Subject: **Safety Recall – Premature Failure, Alternator Bearings.**

Re: Recall 08V-XXX – Premature Alternator Bearing Failures – Fire Potential

INSTRUCTION TO SERVICE ITS: 3768

Remove and replace alternator tensioner and belt.

Fig. 1: Alternator Mounting

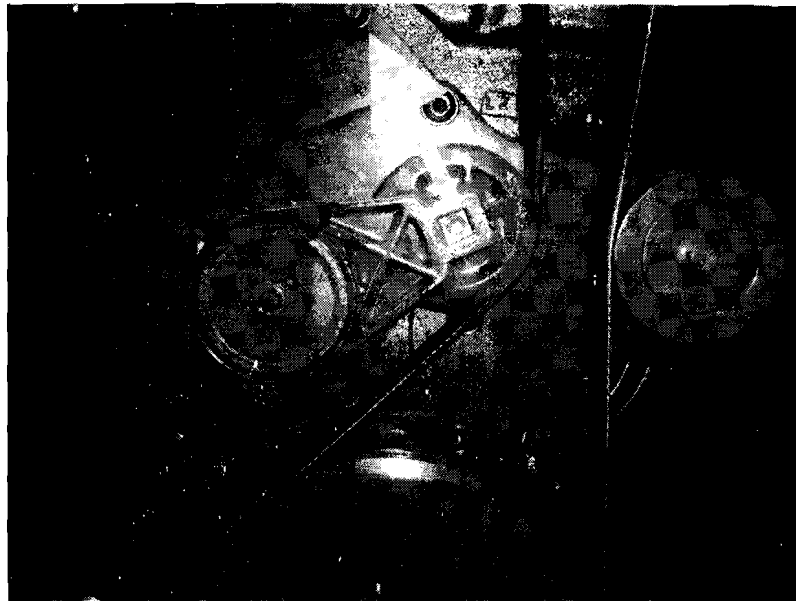
1. Turn the main battery disconnect switch to the "OFF" position.
2. Open the rear engine access door.
3. Open belt guard cover.
4. Use a 1/2" drive breaker bar to rotate the tensioner away from the belt until it stops and relieve belt tension. See Fig. 1 below.

5. Remove the alternator belt while holding the tensioner. Discard the 10-rib belt.
6. Remove tensioner NF P/N 6329037. Discard the tensioner and hex nut.
7. Install new 97 lbf tensioner NF P/N 6361573 (Cummins P/N 2862082). Use new hex nut P/N 6355726. **Tighten nut to 32 FT-LB (43 N-m).**
8. Remove the 10-groove pulley from alternator using pulley tool P/N 6358951 (CEN P/N A10-135). Discard pulley and nut. See Fig. 2.
